## STAFF REPORT

### DESIGN COMMISSION STUDY SESSION

<b>Project No:</b>	DSR20-010
<b>Description:</b>	Shell Station renovation
<b>Applicant/ Owner:</b>	Brad Kaul (Kaul Design Architecture) / Matt Randish (Sun Pacific Energy)
<b>Site Address:</b>	7833 SE 28 <sup>th</sup> St (Parcel Number 545230-0380)
<b>Zoning District</b>	Town Center (TC)
<b>Staff Contact:</b>	Robin Proebsting, Senior Planner
<b>Exhibits:</b>	<ol style="list-style-type: none"> <li>1. Conceptual Plans prepared by Kaul Design Architecture, dated February 25, 2021</li> <li>2. Project Narrative prepared by Brad Kaul</li> <li>3. Shell Convenience Store Addition Parking Memo prepared by Heath &amp; Associates, dated March 2, 2021</li> </ol>

## A0.1

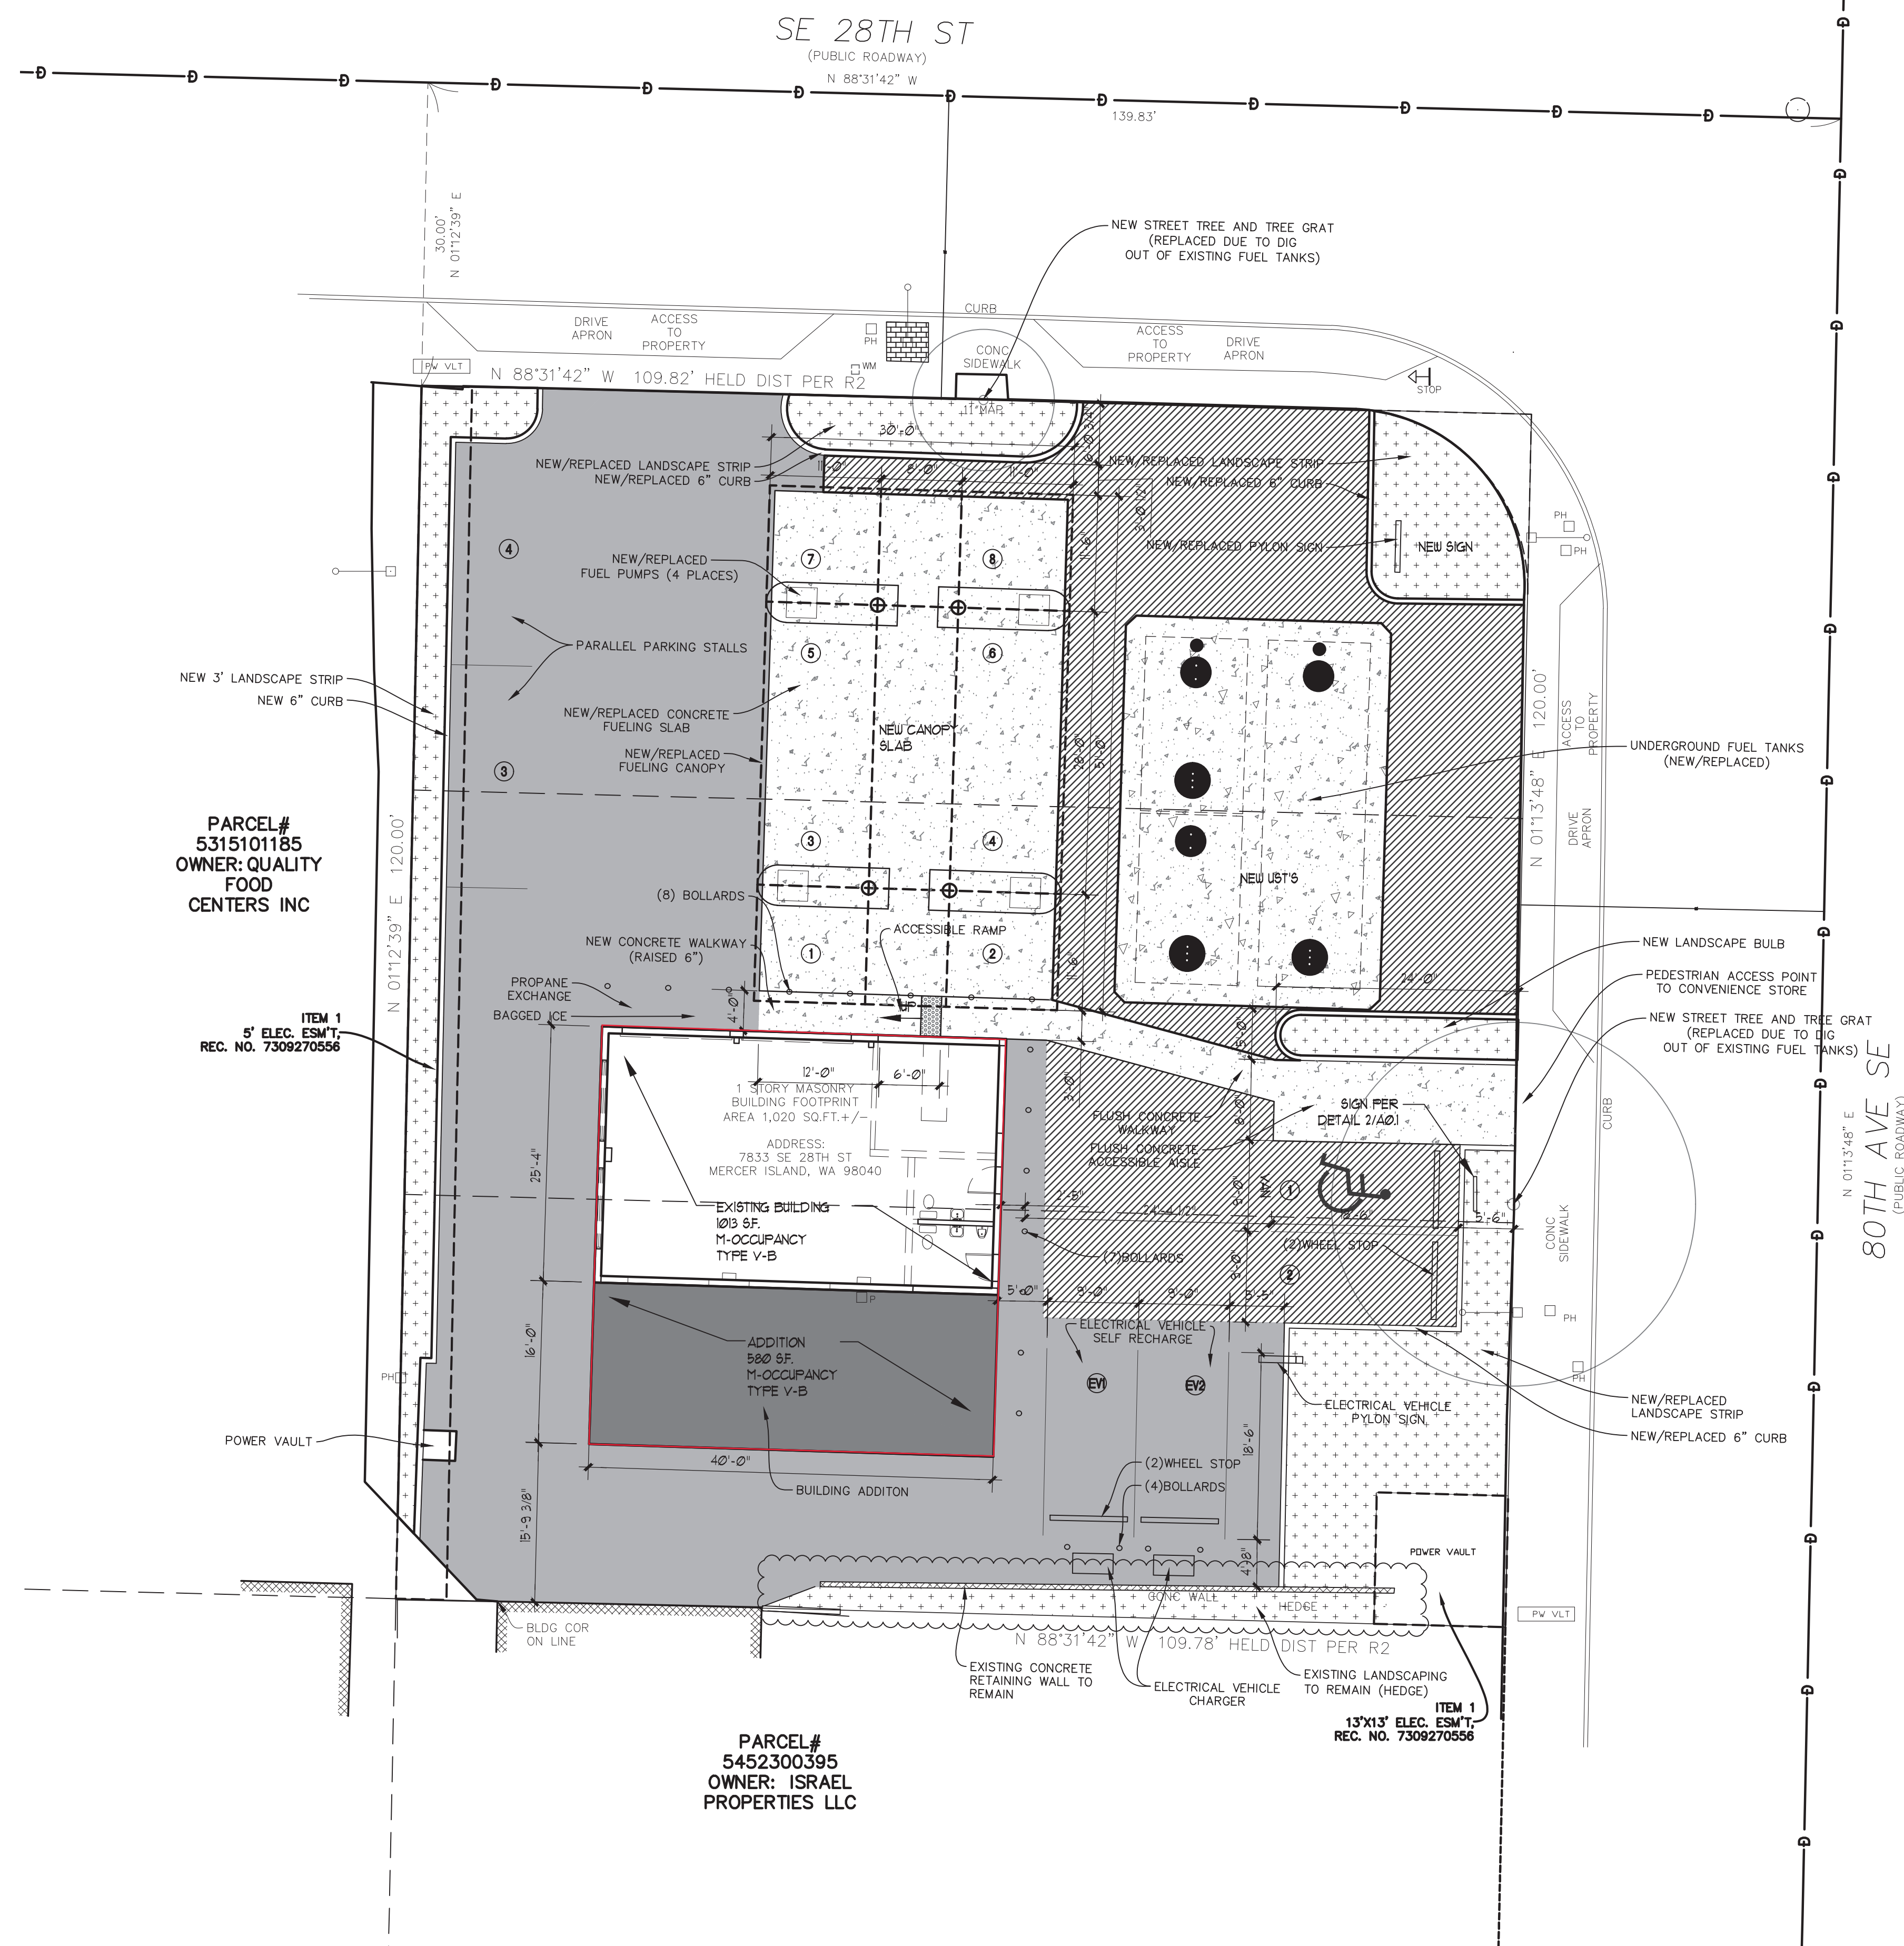
Standards for building entrances are in MICC 19.11.100(B)(6) and are required to be recessed from the façade surface and should use special paving treatment to enhance the entrance. The proposed entrance is defined by an overhead canopy and double doors, and a striped walkway provides pedestrian access from 80th Ave SE, as well as from the ADA parking spot, consistent with this standard (Exhibit 1, sheet A0.1).

Parking standards are established in MICC 19.11.130; general retail land uses are required to provide 2 to 3 parking stalls per 1,000 gross square feet. For the 1,593 gross square feet proposed as the finished size of the convenience store (Exhibit 1, sheet A0.1), 3 stalls per 1,000 square feet would equal 4.8 stalls. 6 stalls are provided by the proposed design, providing enough parking for even the “worst-case scenario”. This is confirmed in the parking memo submitted with this application (Exhibit 3).
